CONSTRUCTION DOCUMENTS FOR:
HAVEN VALLEY
 (LETA DR.) BRADLEY RD/ALTURAS DR.
 SECURITY, EL PASO COUNTY, COLORADO

v1_Construction Drawings.pdf Markup Summary 10-19-2023

NEW HAVEN PT ROAD & STORM PLAN & PROFILE
PROJECT NO. 21085-03CSCV
DRAWING NO.

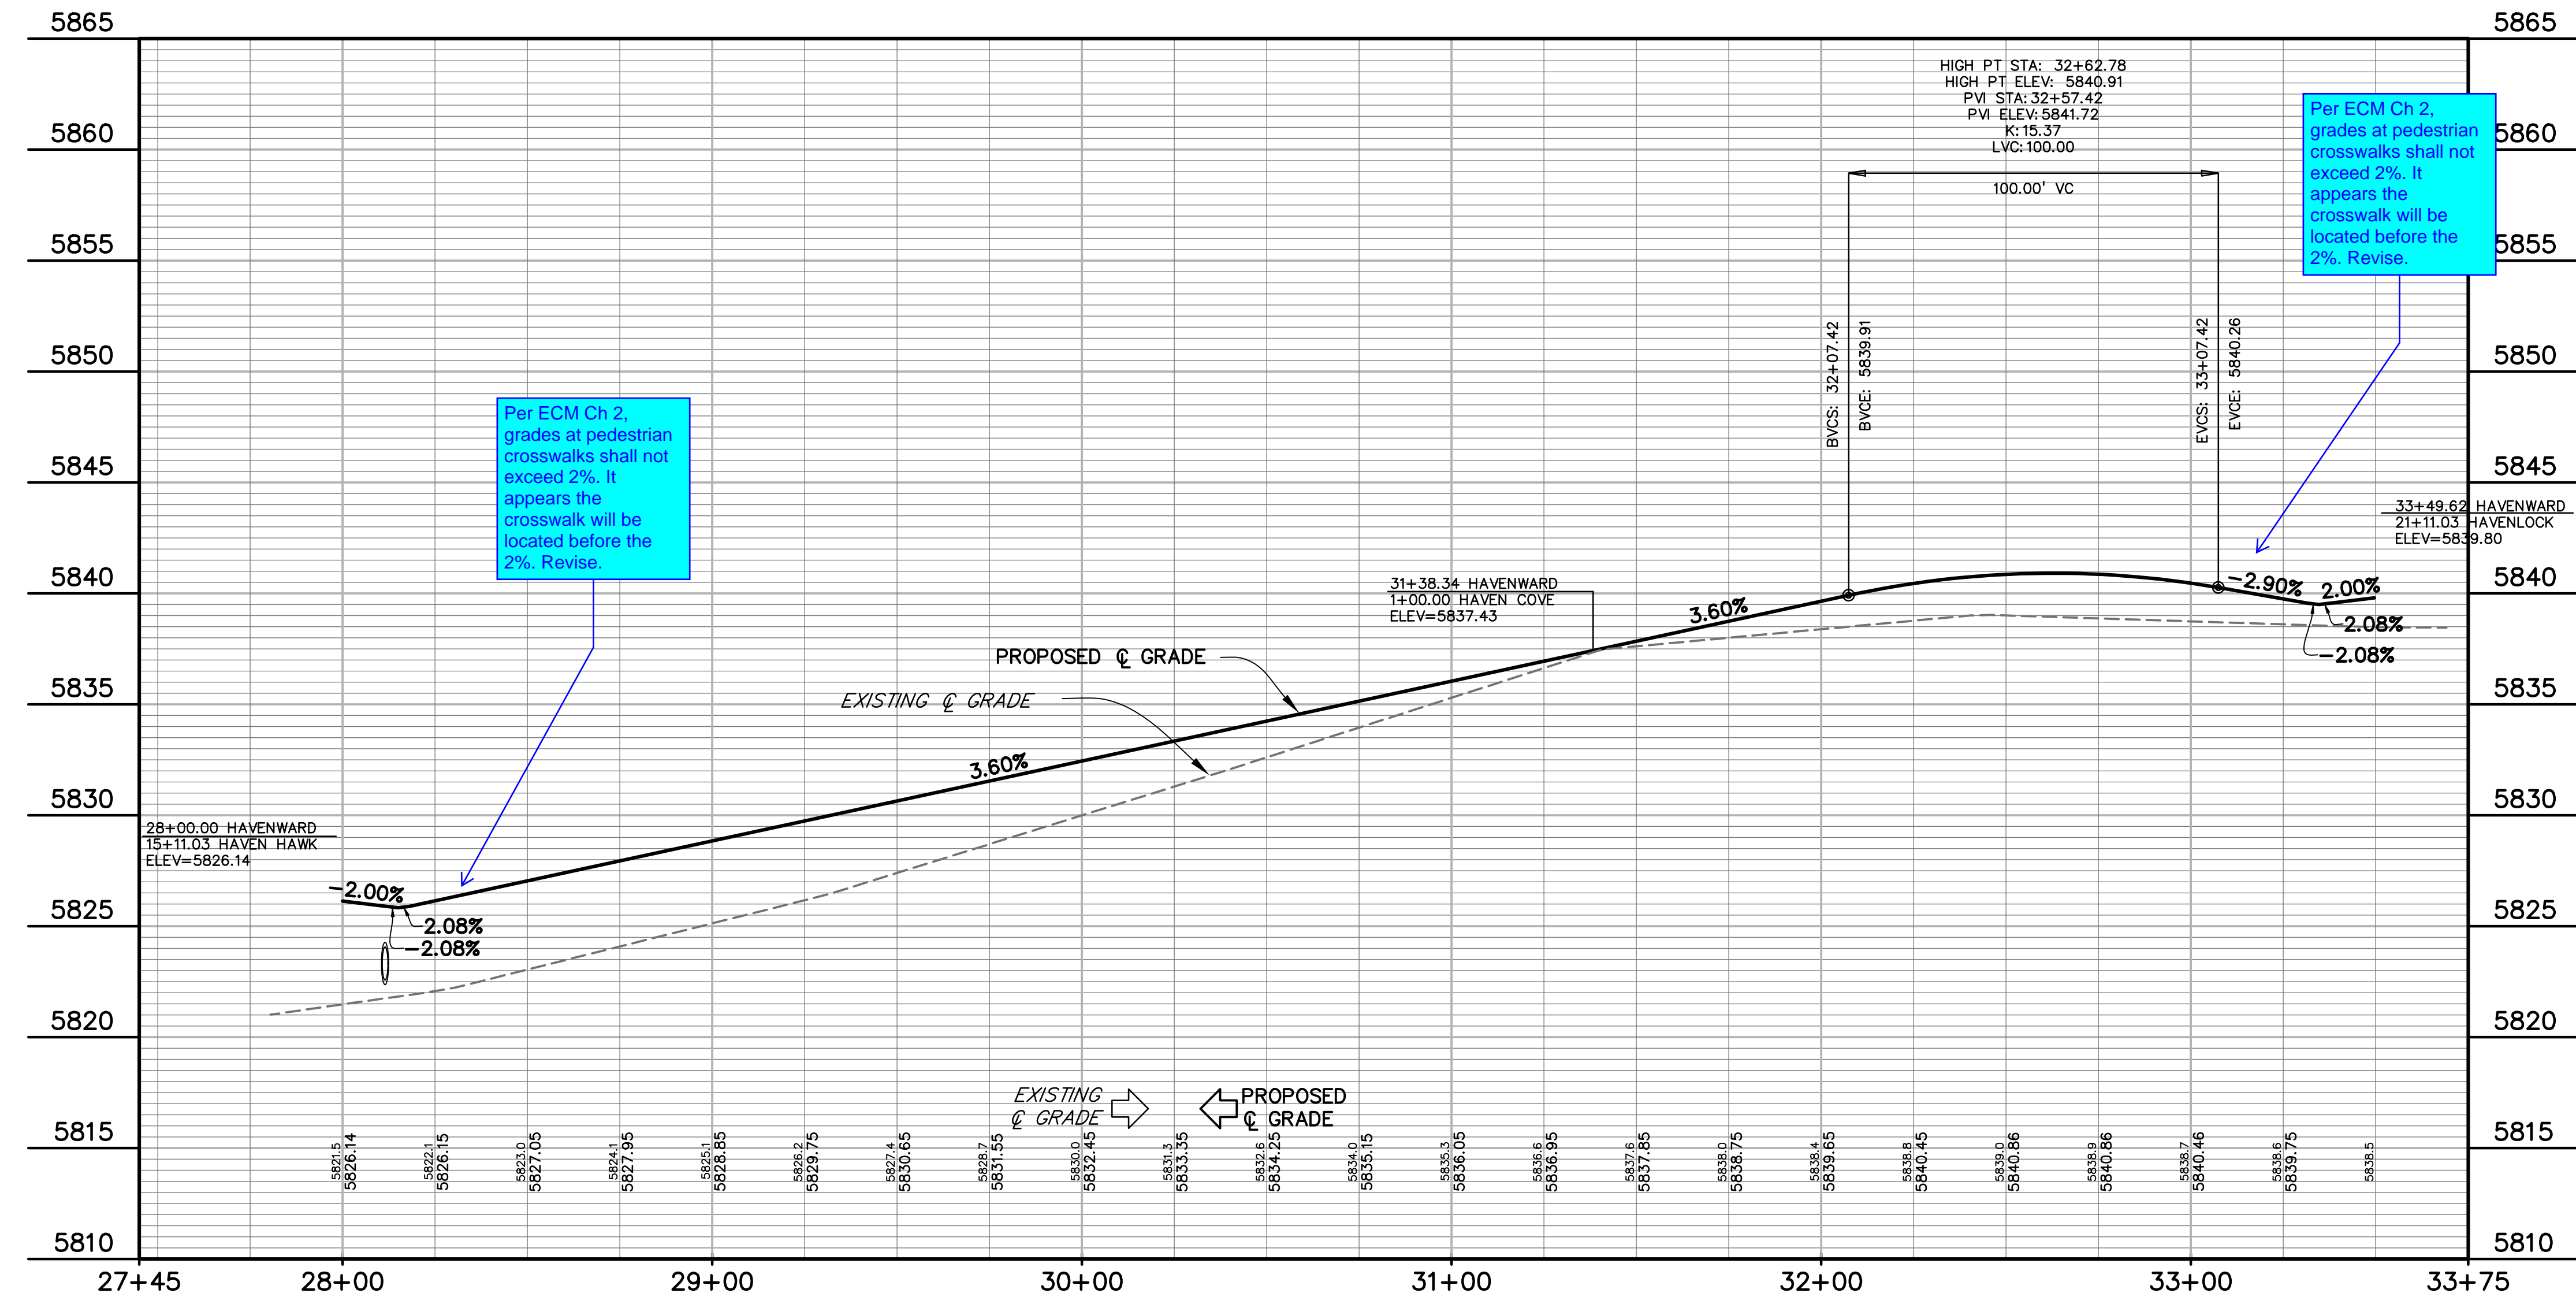
Update plans to show pedestrian ramp grades if a separate sheet will not be provided for this.

Revise plans to show flowline grade of curb. Per ECM Ch 2 minimum grade is 0.5%.

HAWK HAVEN ROAD & STORM PLAN & PROFILE
 PROJECT NO. 21085-03CSCV
 DRAWING NO.

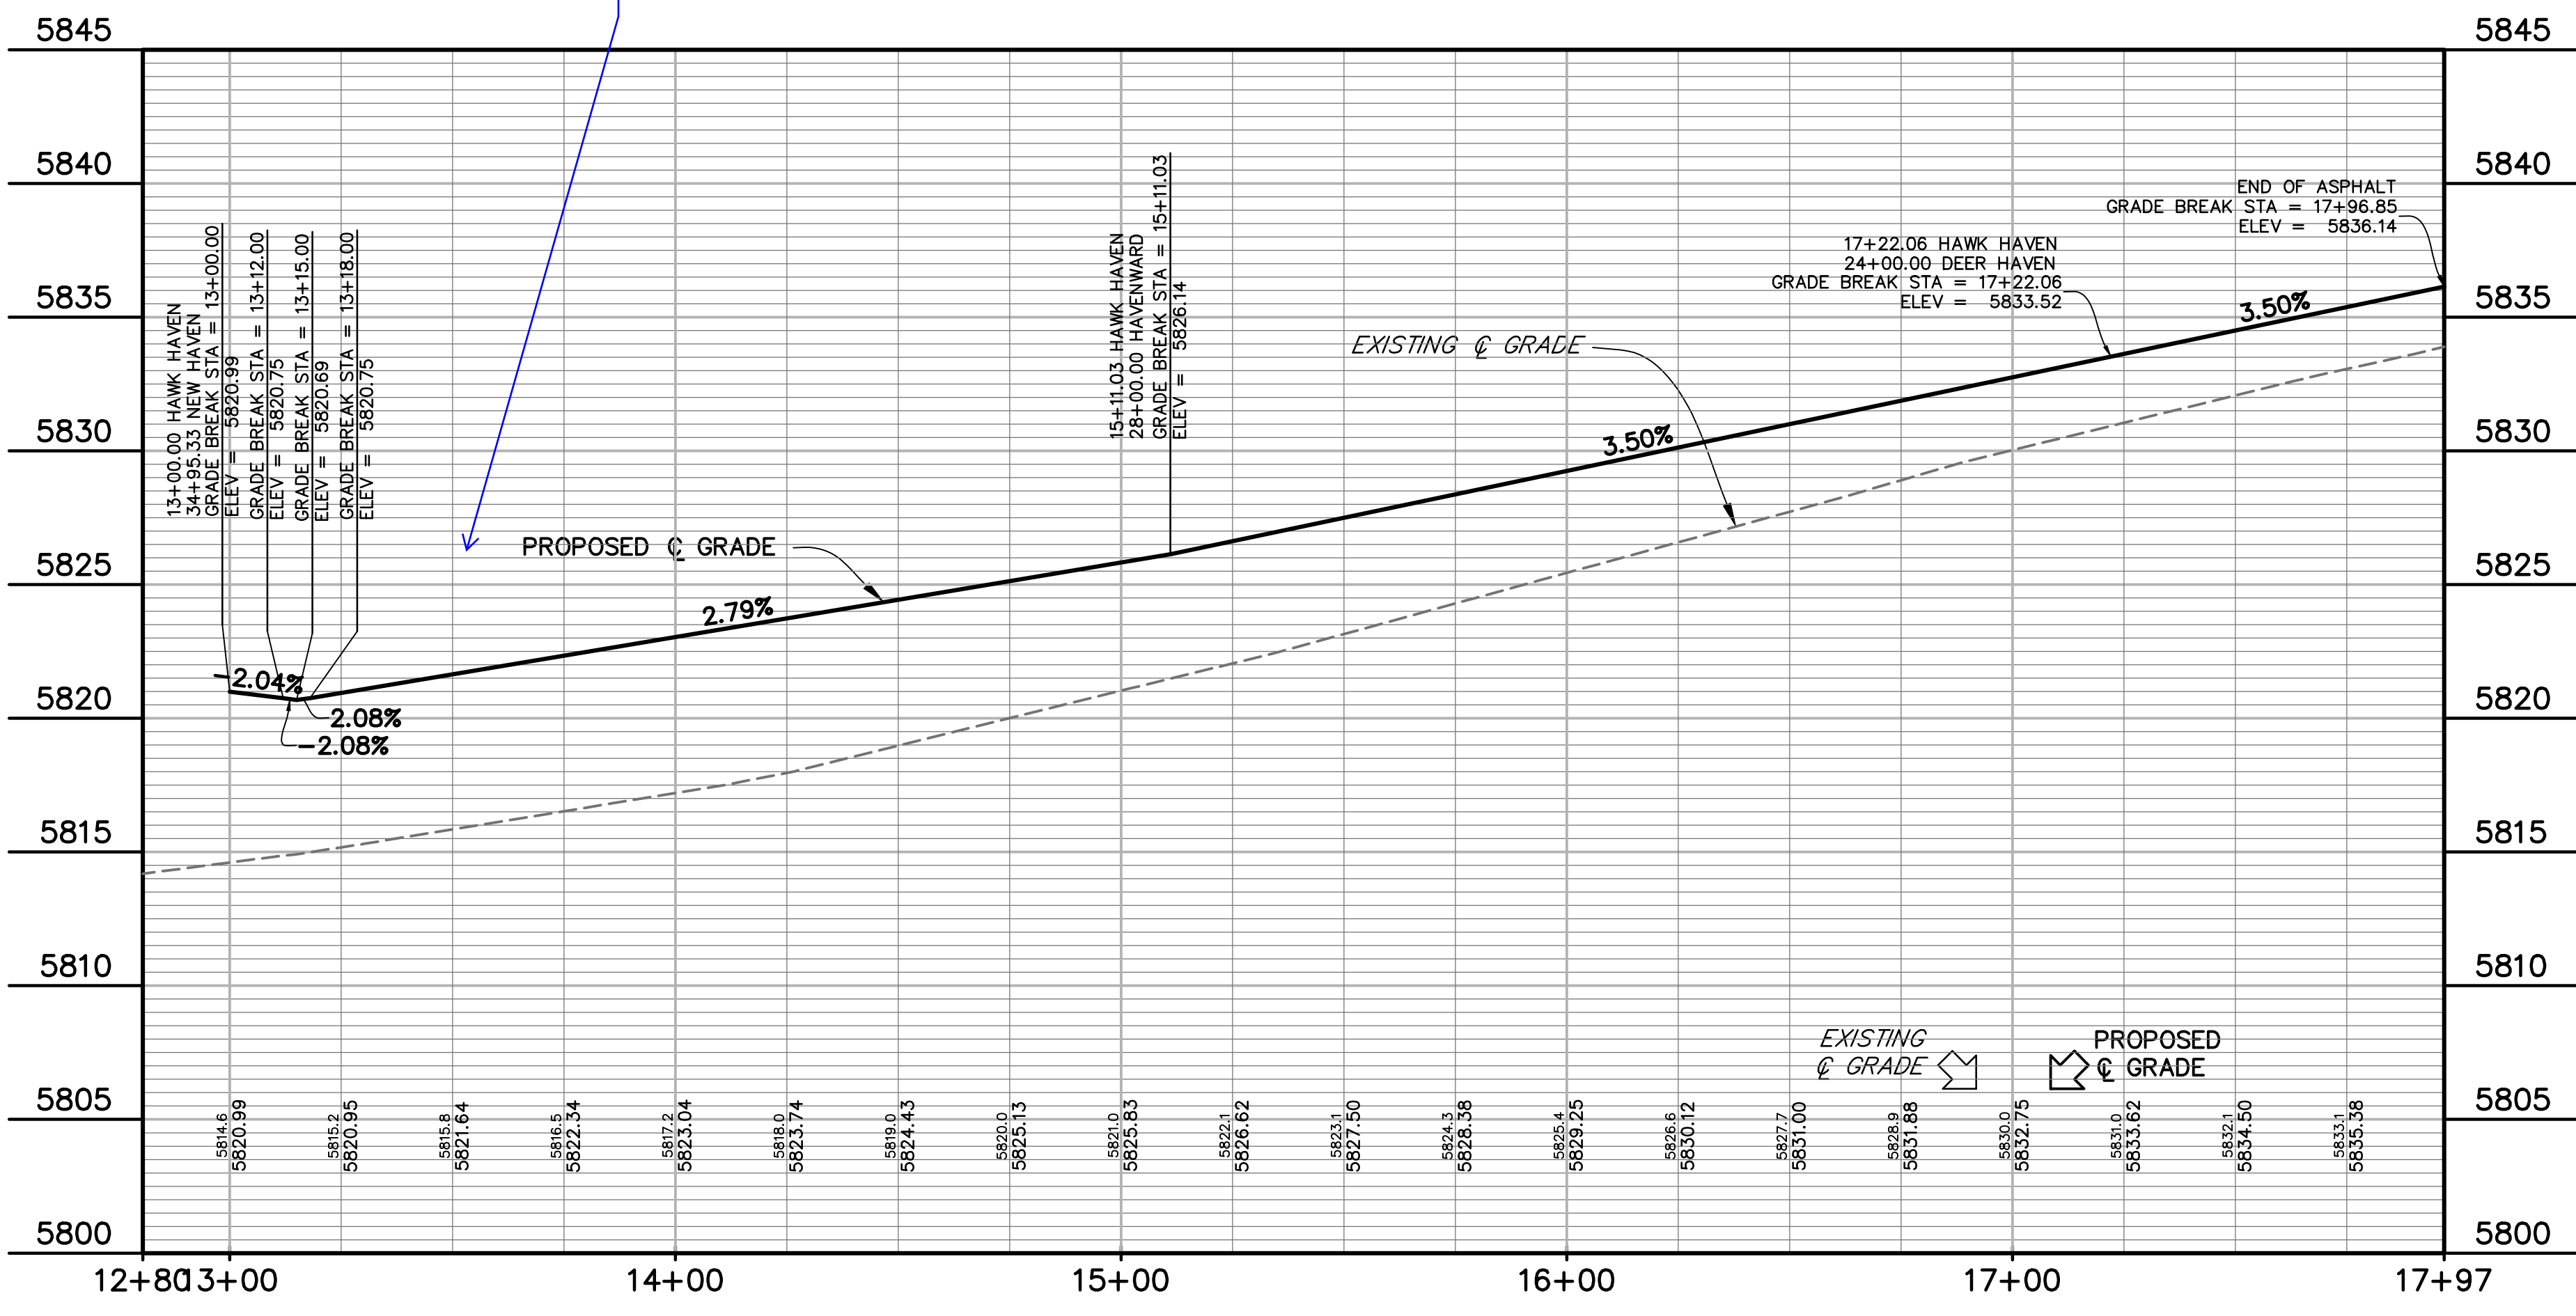
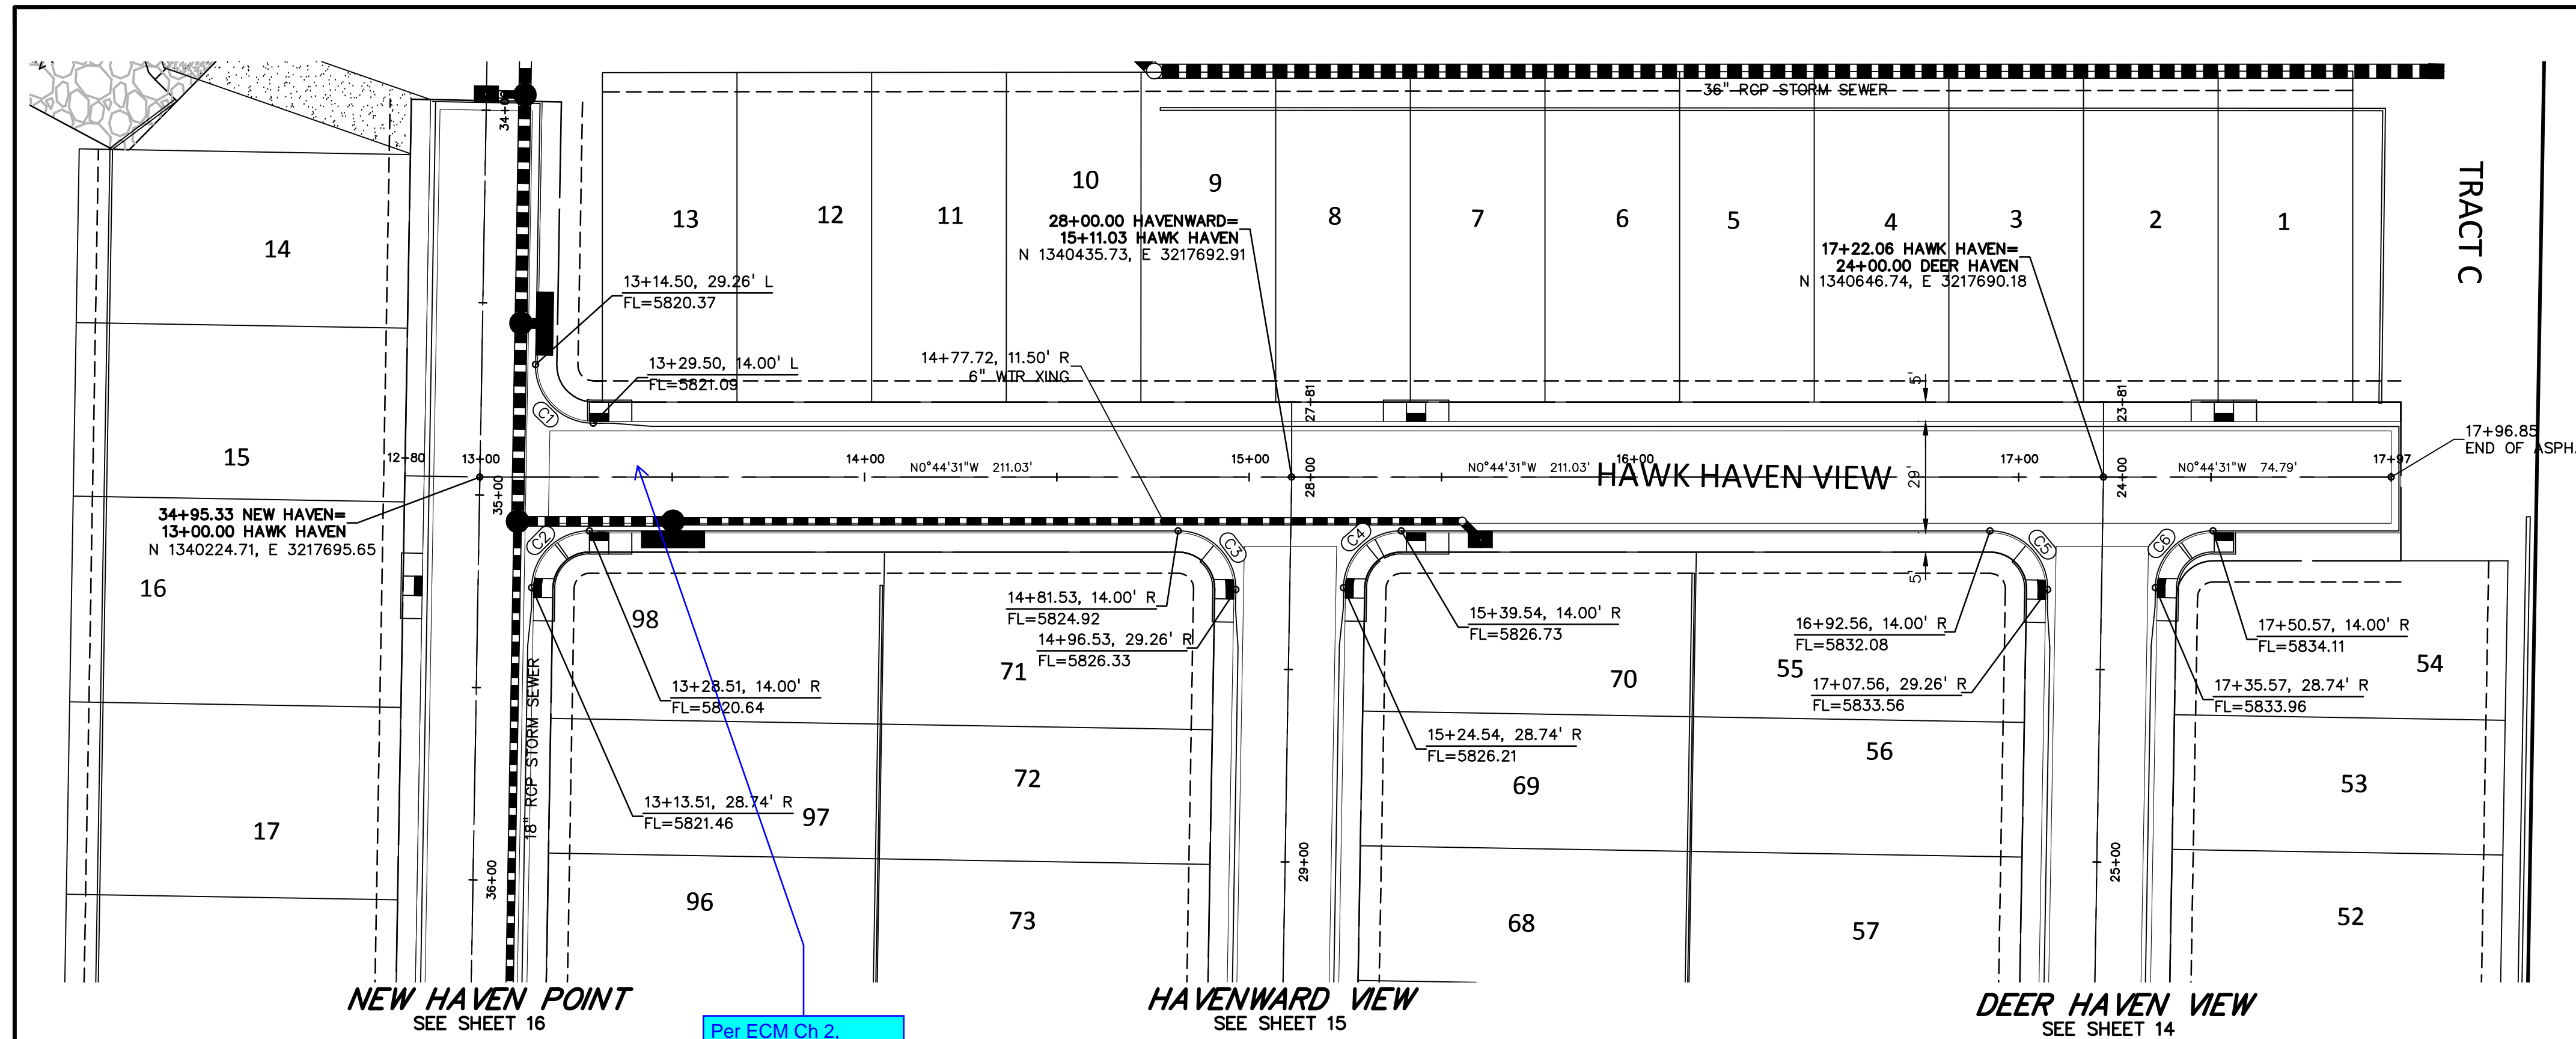
Update plans to show pedestrian ramp grades if a separate sheet will not be provided for this.

Revise plans to show flowline grade of curb. Per ECM Ch 2 minimum grade is 0.5%.

Per ECM Ch 2, grades at pedestrian crosswalks shall not exceed 2%. It appears the crosswalk will be located before the 2%. Revise.
